Auto-Lift Guard Fall Arrest Assembly

Technical Bulletin 2608-1 for Stolle SRC Shell Systems

Previous belt design guard fall arrest assembly

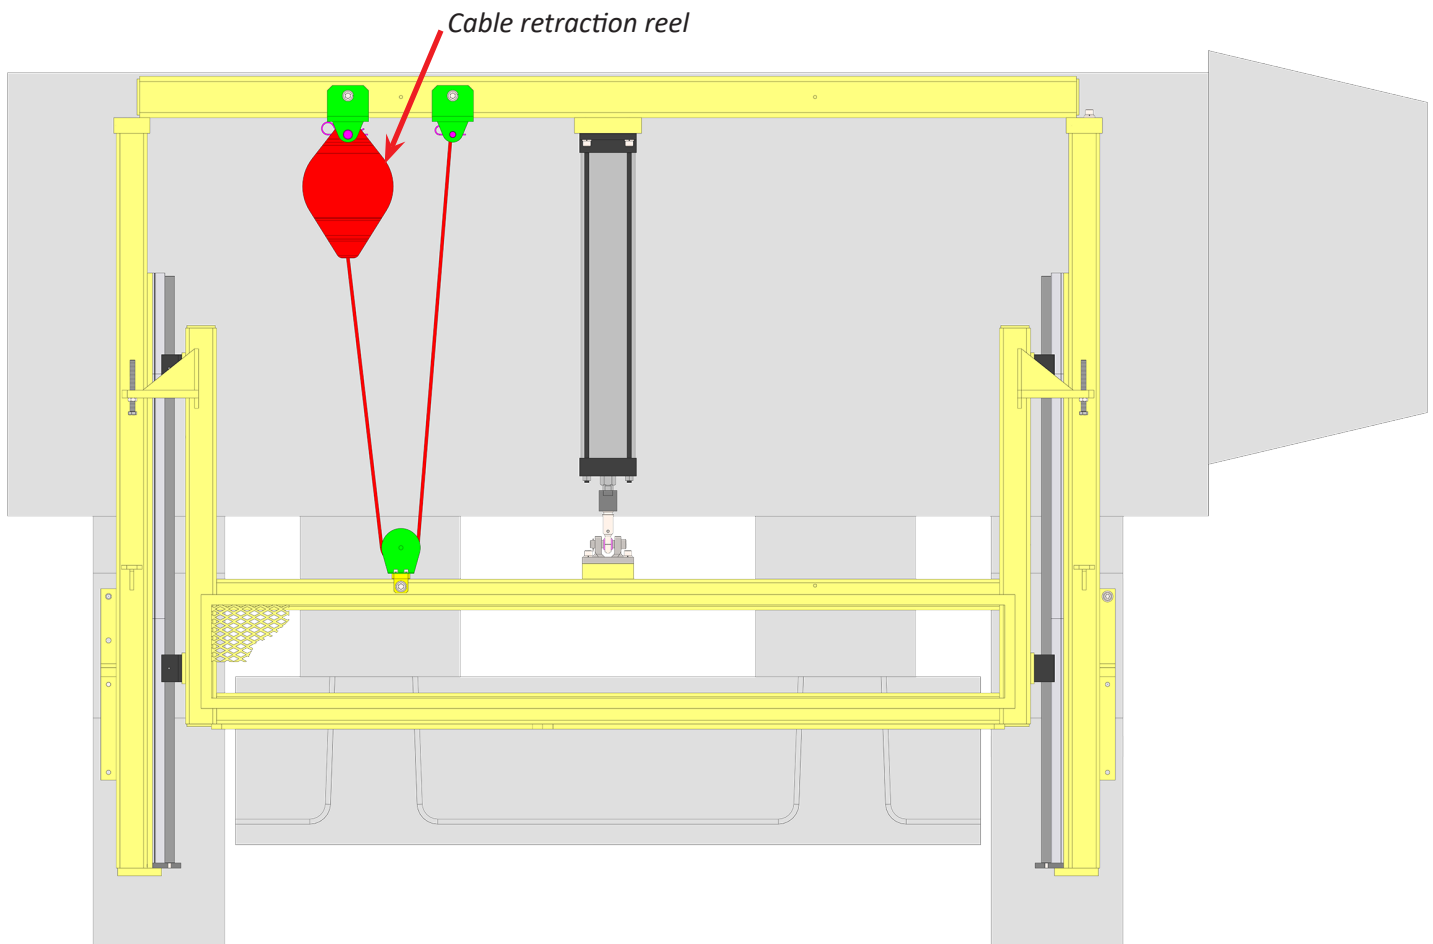
Stolle has a new fall arrest assembly for the auto-lift guards on our shell system presses. The purpose of the fall arrest assembly is to prevent a press guard that is raised by a pneumatic cylinder from falling if the cylinder loses air pressure or other reason, potentially causing injury to personnel. The previous system used two fabric belts with retraction reels to prevent a raised guard from falling. The new system uses a single cable with a pulley and retraction reel, making it more reliable and simpler to maintain.

The new cable assembly will be provided on all new Stolle shell systems with pneumatic auto-lift guards, and belt assemblies will no longer be available. A new cable fall arrest kit is available to replace belt assemblies on existing shell systems, and can be installed by a Stolle service technician.
